**Work Order ID 64601**

DRAWING NO. D2580	TITLE 205 SKIDTUBE ASSEMBLY	REV. D	DART AEROSPACE LTD ENGINEERING ORDER		D.E.O. NO. D2580-D-1	SHEET NO. SHEET 1 OF 1	SCALE NTS
DRAWN <i>UP</i>	CHECKED <i>L</i>	MFG. APPR. <i>E</i>	APPROVED <i>MP</i>		DE APPR. <i>MP</i>		
DATE 10.09.22	DATE 10.11.04	DATE 10.11.04	DATE 10/11/04		DATE 10.11.04

**PURPOSE:**

CHANGE ALL WELDED CROSSBOLT SPACERS TO SWAGED SPACERS

SECTION D-D & SECTION H-H ARE AMENDED AS FOLLOWS:

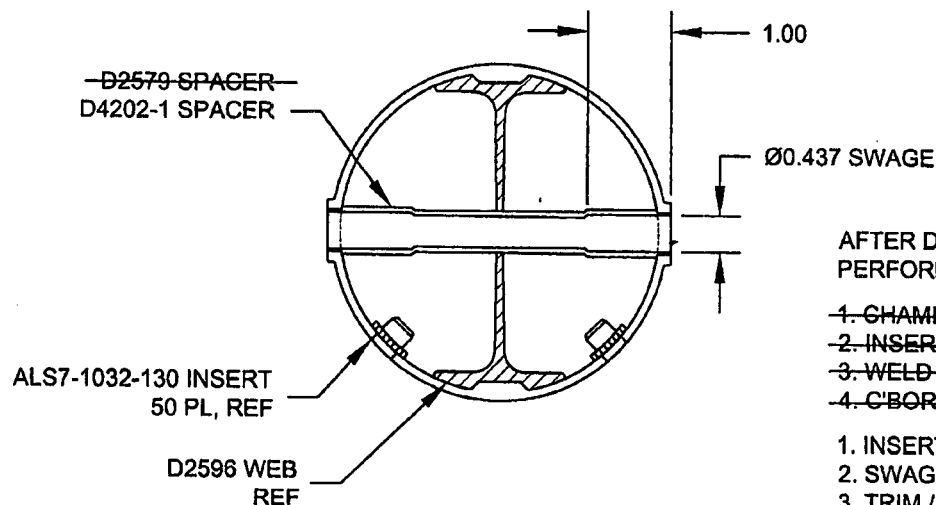
WAS

QTY	QTY	PART NUMBER	DESCRIPTION
-041	-045		
20	24	D2579	CROSS BOLT SPACER

AFTER DRILLING AND BENDING ASSEMBLY  
PERFORM THE FOLLOWING FOR Ø0.508 HOLES ONLY:

1. CHAMFER HOLE 0.050 X 45°
2. INSERT D2579 SPACER (20 PLACES)
3. WELD INTO PLACE AND GRIND FLUSH
4. C-BORE D2579 SPACER TO Ø0.437 X 1.00 DEEP

IS

20	24	D4202-1	SPACER
----	----	---------	--------

1. INSERT D4202-1 SPACER, 20 PL (-041) OR 24 PL (-045)
2. SWAGE TO Ø0.437 X 1.00 DEEP PER QSI 002
3. TRIM / GRIND FLUSH PER QSI 002
